**Cascade Steel Rolling Mills, Inc.**

**Re: Cascade Steel Rolling Mills, Inc.  
CAO Emissions Inventory**

Cascade Steel Rolling Mills (“CSRM”) is in receipt of your letter dated August 26, 2022 requesting additional information pertaining to our Cleaner Air Oregon Air Toxics Emissions Inventory (“CAO ATEI”) submitted to the Department on May 9, 2022. Below we have repeated the comments and information requests provided in the August 26<sup>th</sup> letter (in italics) and provided our response.

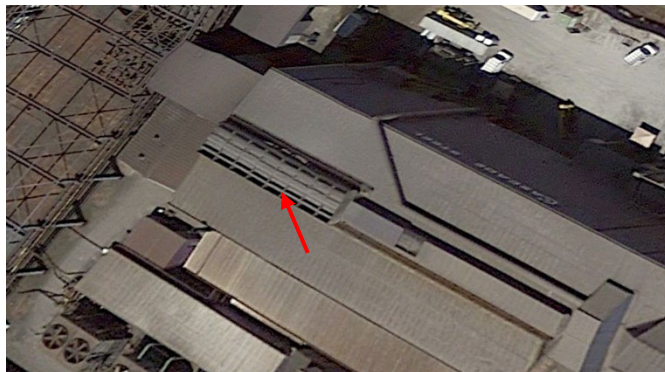
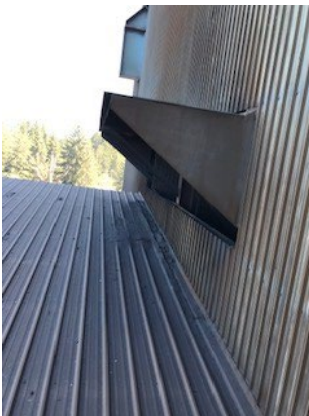
12. *Please provide the following additional documentation to support the emissions inventory:*
- a. *Additional information related to the 2019 source test:*
    - i. *Laboratory analysis data for cadmium (CASRN 7440-43-9) and vanadium (CASRN 7440-62-2);*
    - ii. *Types and quantities of alloys produced during the 2019 Emissions Testing; and*
    - iii. *Photographs or annotated design documents indicating the billet cutting and roof monitor sample locations.*

Specific sample locations were provided in Appendix B of the 2019 source test. A photo of the billet cutting vent and an aerial of the roof monitor are provided below.
